MODIFICATION APPLICATION

TITLE
ROOF PLAN - PHASE B (REVISED PLAN)

PROJECT
RPAC
26 ALBION STREET WAVERLEY NSW 2024

SCALE: 1: 200 @ A1	JOB No: 1212
CHECKED: PDM	DRAWN: DBV/RM
DRAWING No: 4.55(1B)107	REV B

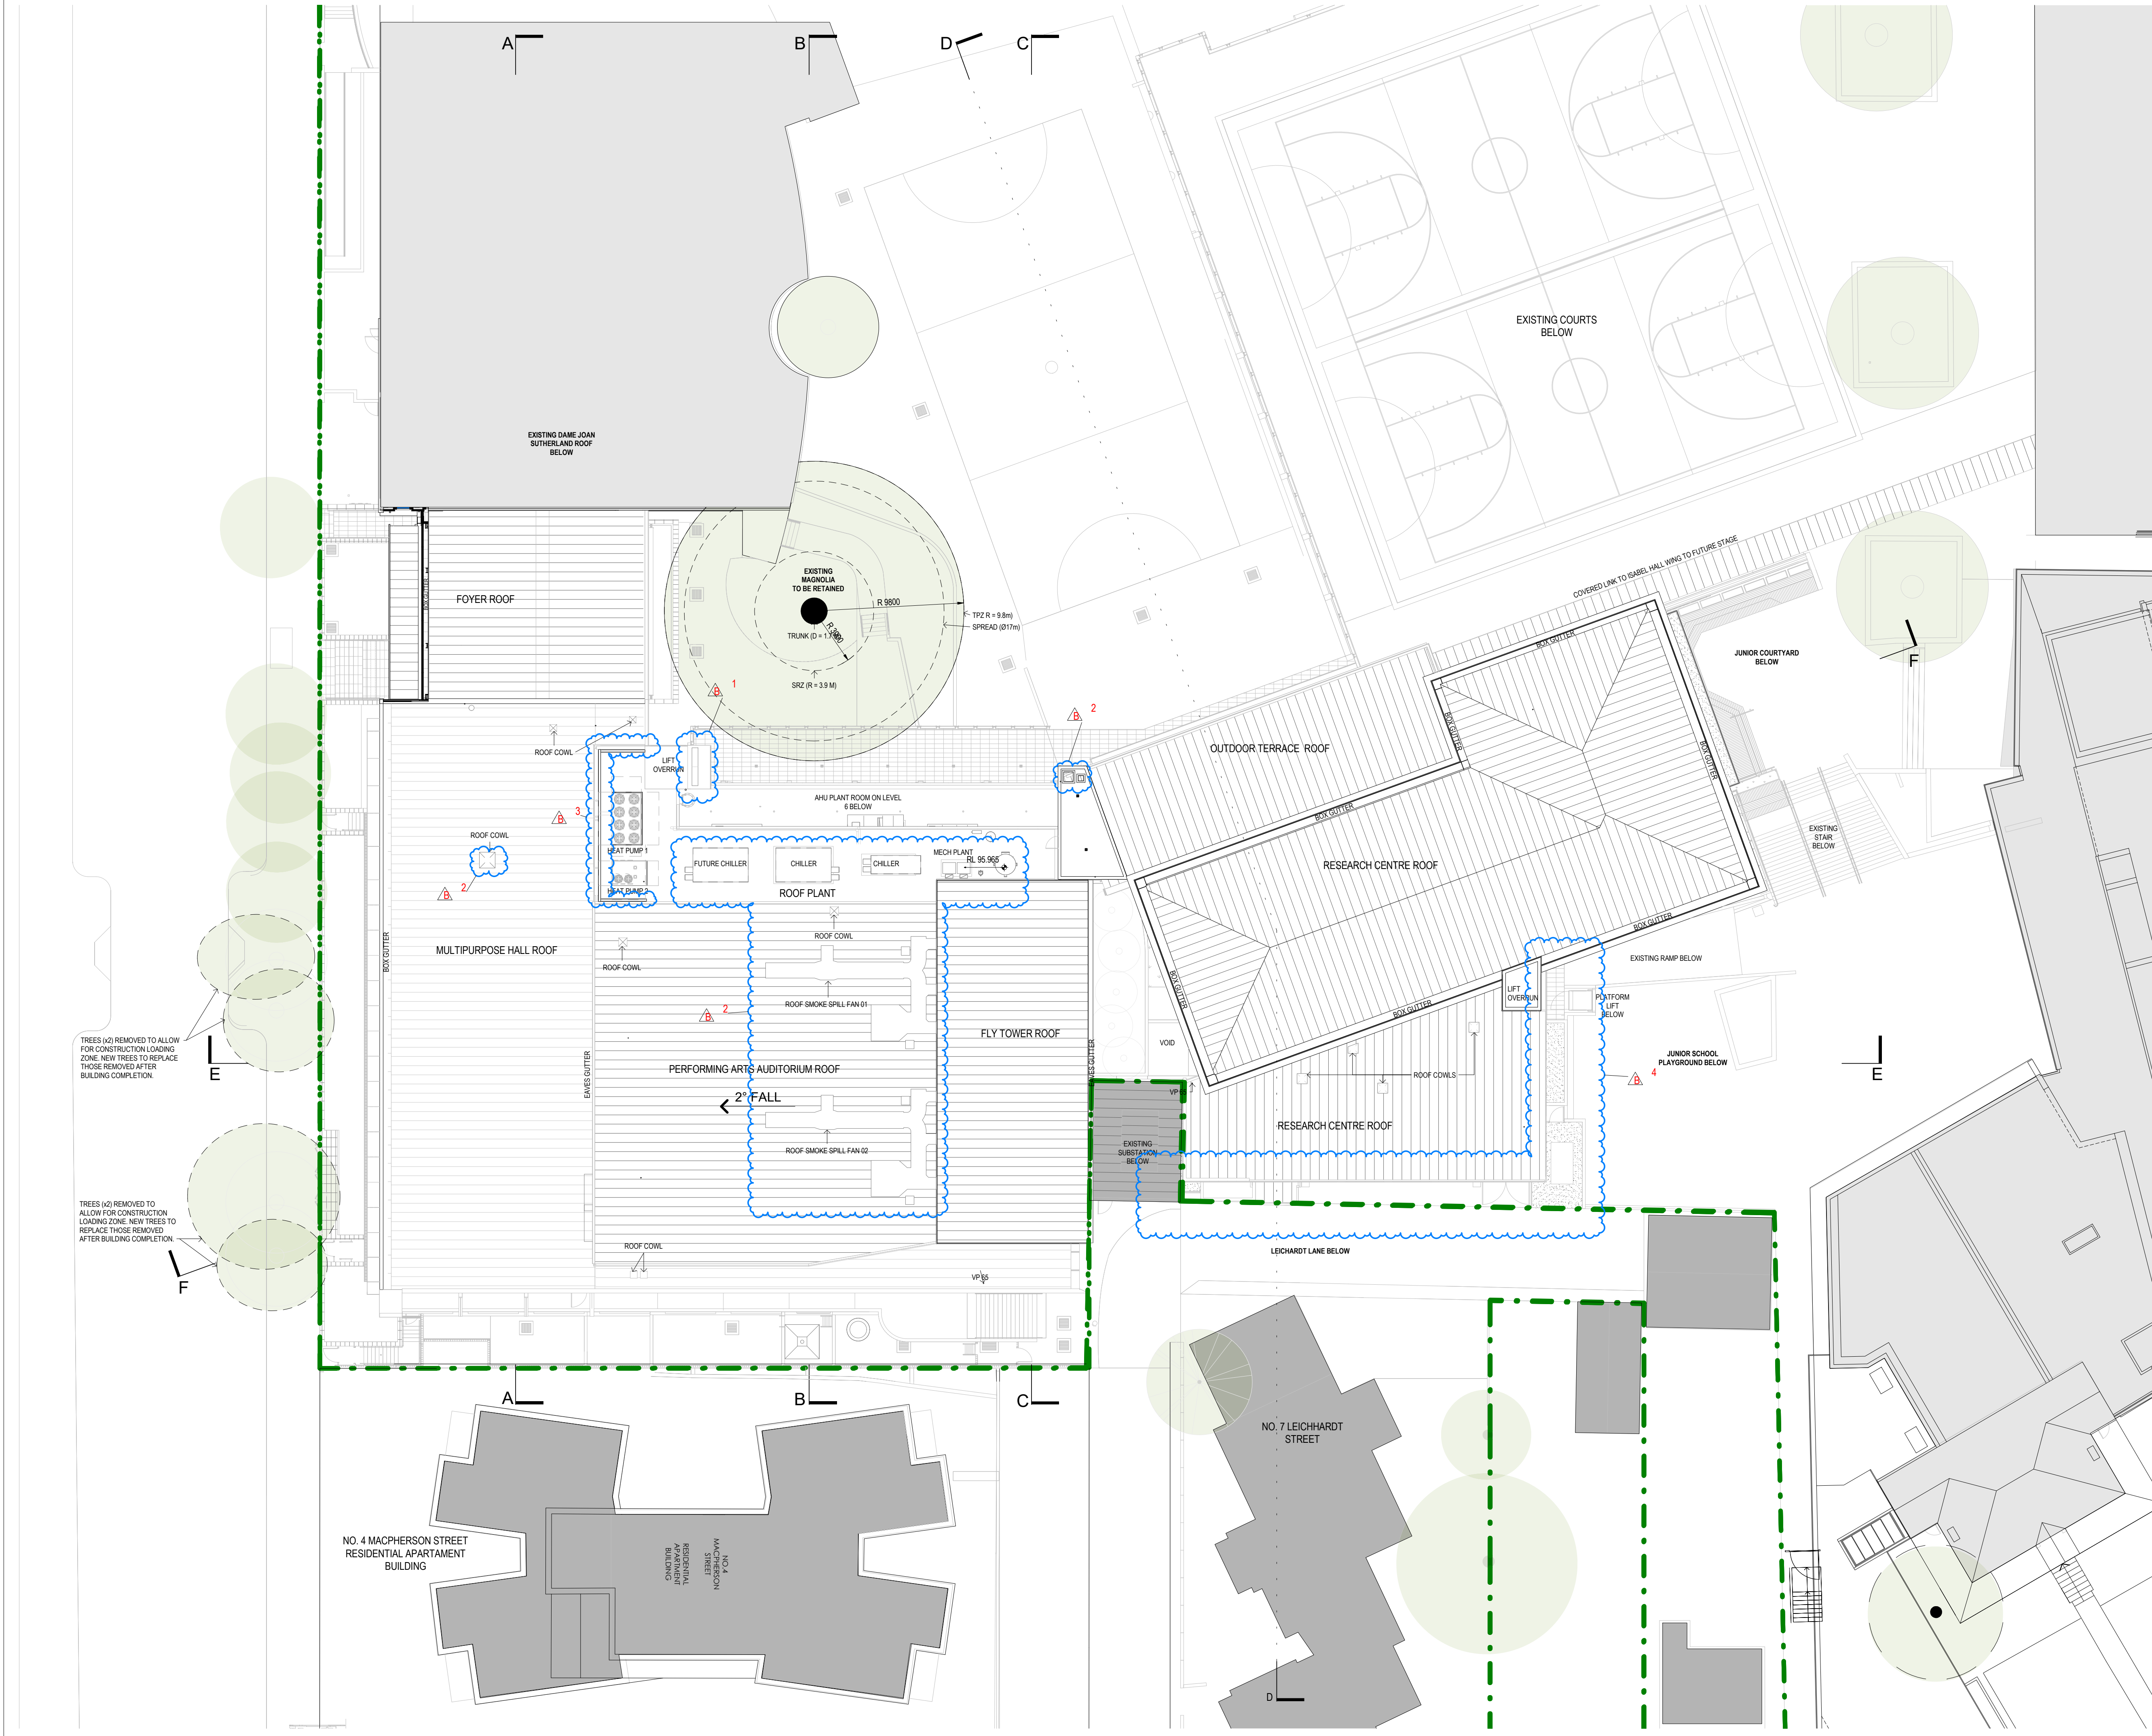
- LIST OF CHANGES ROOF LEVEL:
1. REVISED RISER SIZE FOR SERVICES RETICULATION.
 2. MECHANICAL SERVICES AT ROOF PLANT AND ROOF LEVEL UPDATED TO REFLECT FINAL DESIGN.
 3. SCREENING TO PLANT FOR COMPLIANCE WITH CONDITIONS OF CONSENT.
 4. NEW SUBSTATION LOCATION AND REVISED SERVICE VEHICLE ZONE IN LEVEL 4 (LEVEL BELOW).

LEVEL 7 - PHASE B (REVISED PLAN)

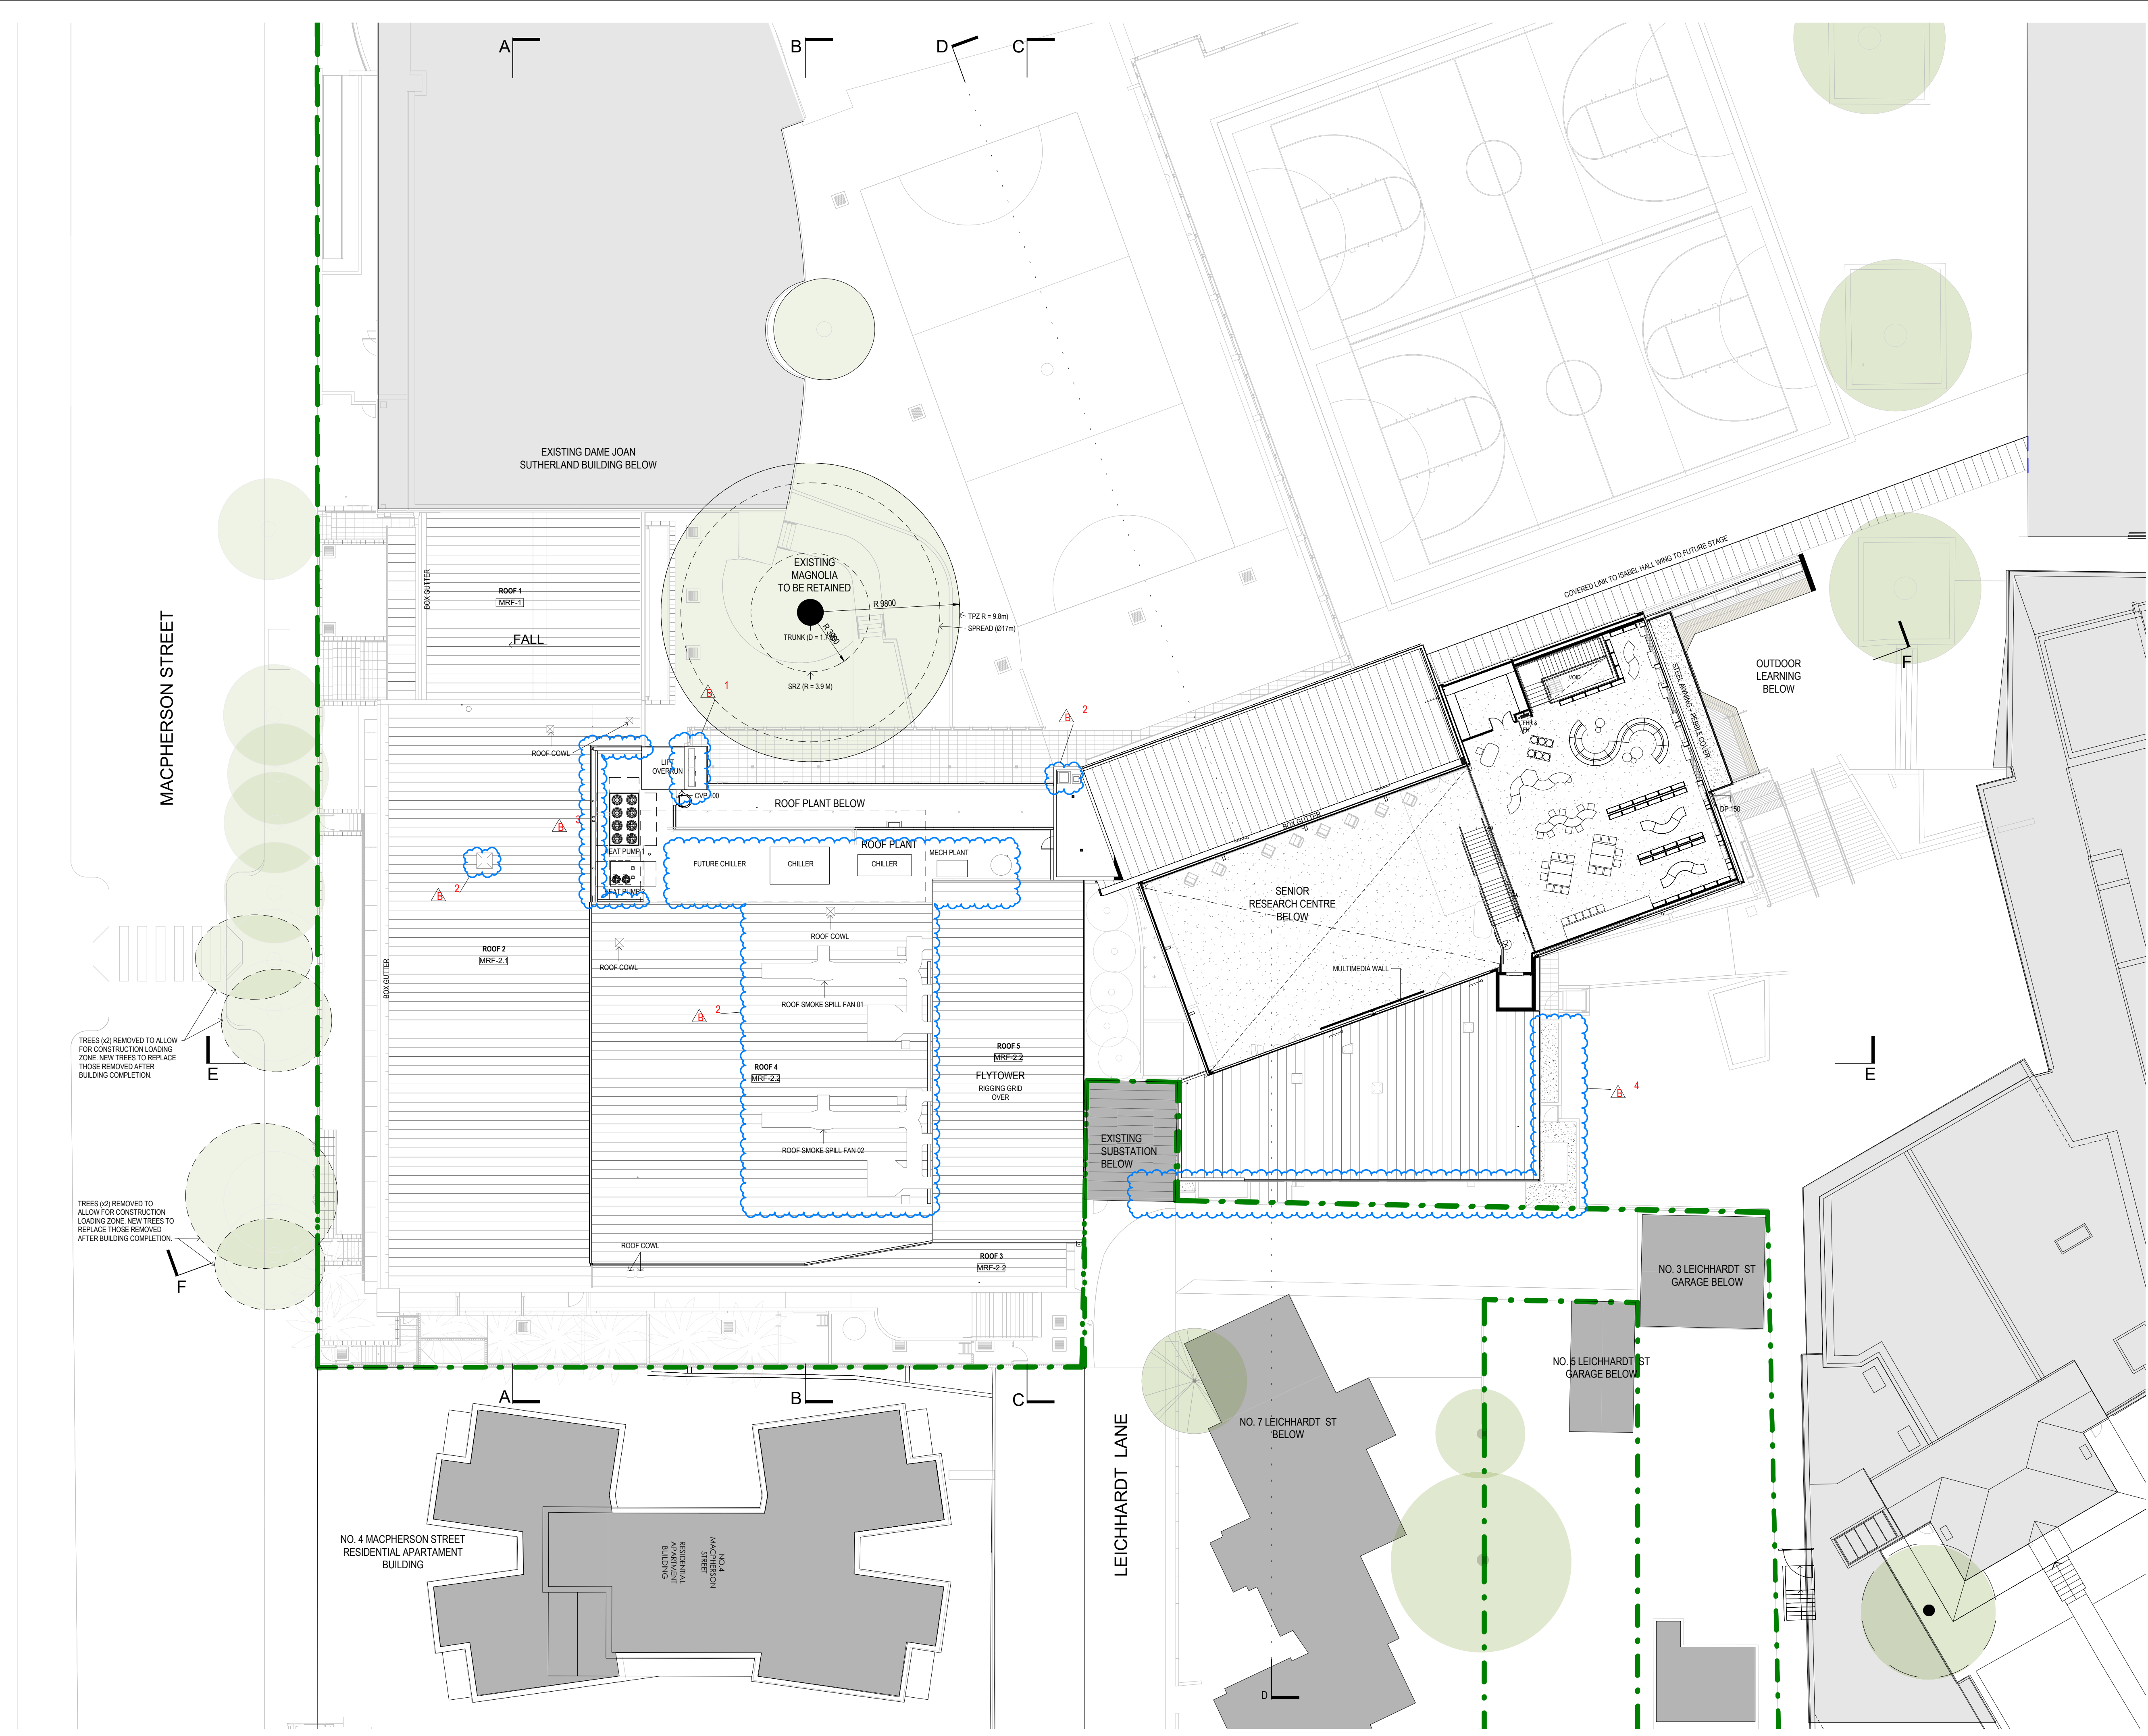
- LIST OF CHANGES LEVEL 7:
1. REVISED RISER SIZE FOR SERVICES RETICULATION.
 2. MECHANICAL SERVICES AT ROOF PLANT AND ROOF LEVEL UPDATED TO REFLECT FINAL DESIGN.
 3. SCREENING TO PLANT FOR COMPLIANCE WITH CONDITIONS OF CONSENT.
 4. NEW SUBSTATION LOCATION AND REVISED SERVICE VEHICLE ZONE IN LEVEL 4 (LEVEL BELOW).

LEVEL 5 - PHASE B (REVISED PLAN)

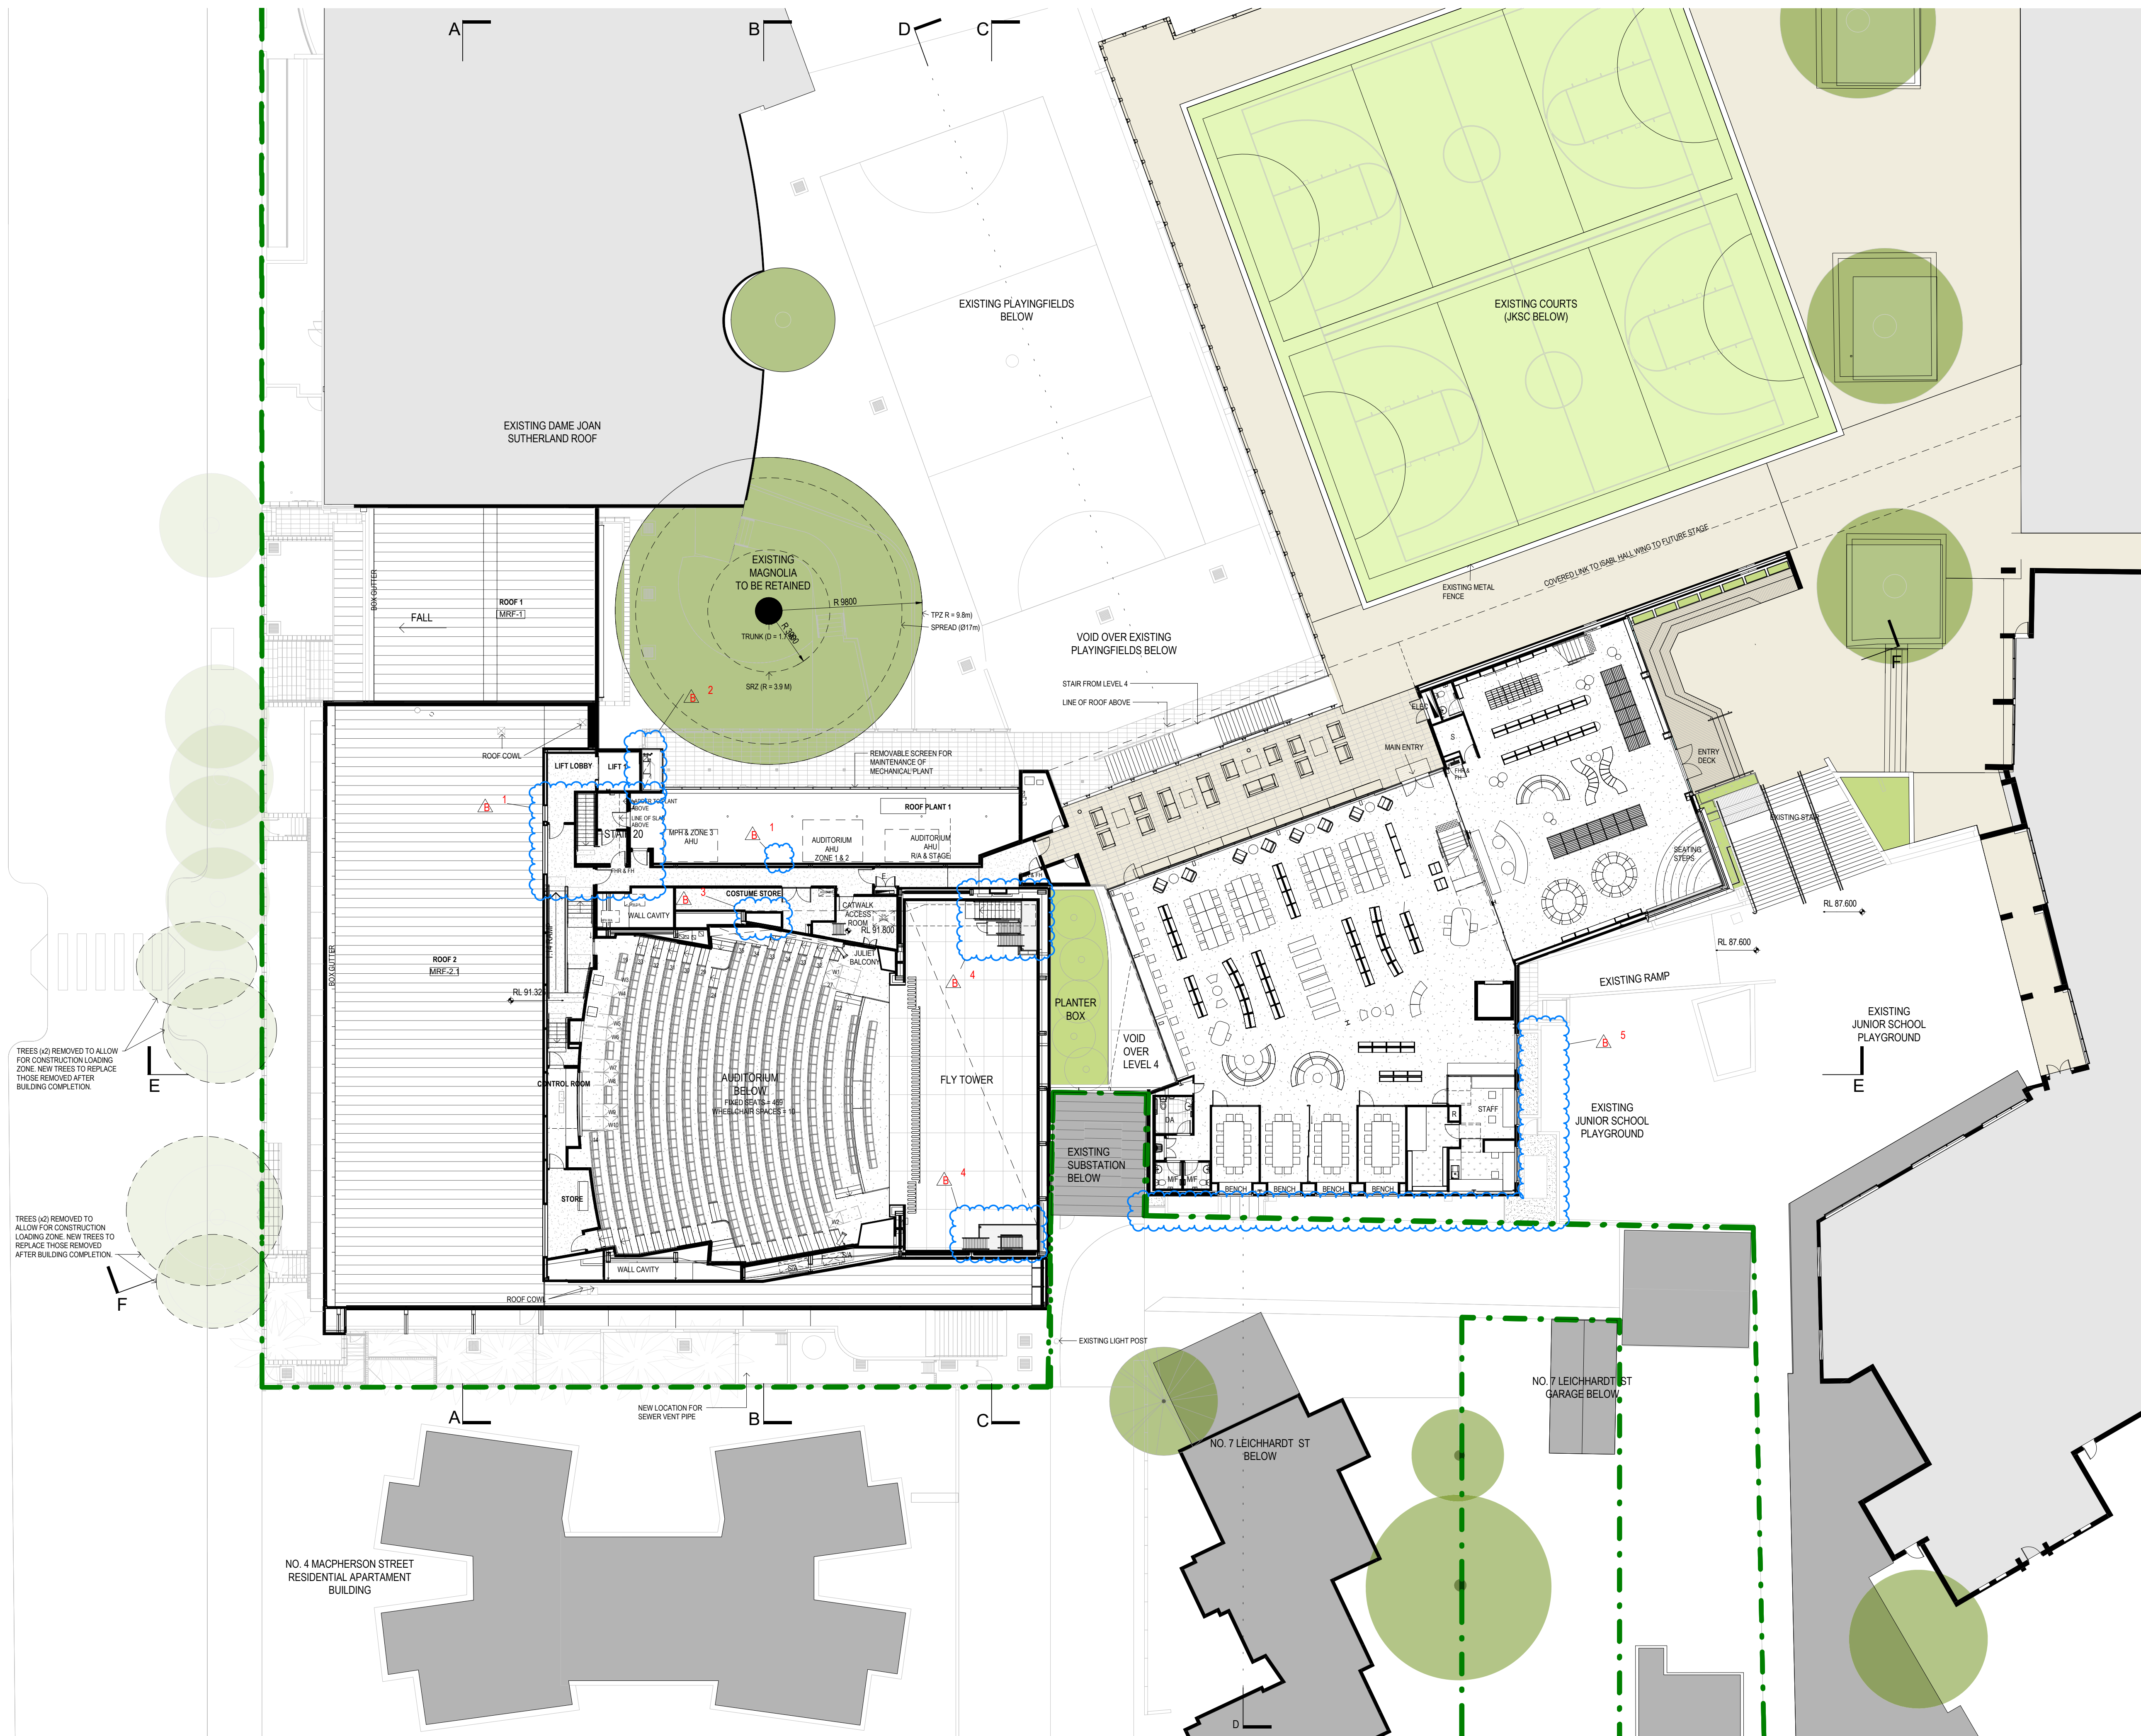
- LIST OF CHANGES LEVEL 5:
1. MEETING ROOM, CORRIDOR, AND STORE LAYOUT REVISED TO INCLUDE ACCESSIBLE BATHROOM TO SERVICE RPAC LEVEL 5 AND EXISTING DAME JOAN SUTHERLAND CENTRE FOR ACCESSIBILITY COMPLIANCE.
 2. REVISED LEVEL 5 LIFT CORRIDOR AND ADJACENT ROOMS LAYOUT FOR ACCESSIBILITY COMPLIANCE.
 3. SERVICES RISER AND CEILING CAVITY REVISED FOR SERVICES RETICULATION
 4. NEW MECHANICAL PLENUM INCLUDED FOR SERVICES RETICULATION
 5. REVISED VERTICAL ACCESS ARRANGEMENT TO THE STAGE CATWALKS FOR COMPLIANCE AND IMPROVED FUNCTIONALITY.
 6. NEW SUBSTATION LOCATION AND REVISED SERVICE VEHICLE ZONE IN LEVEL 4 (LEVEL BELOW)
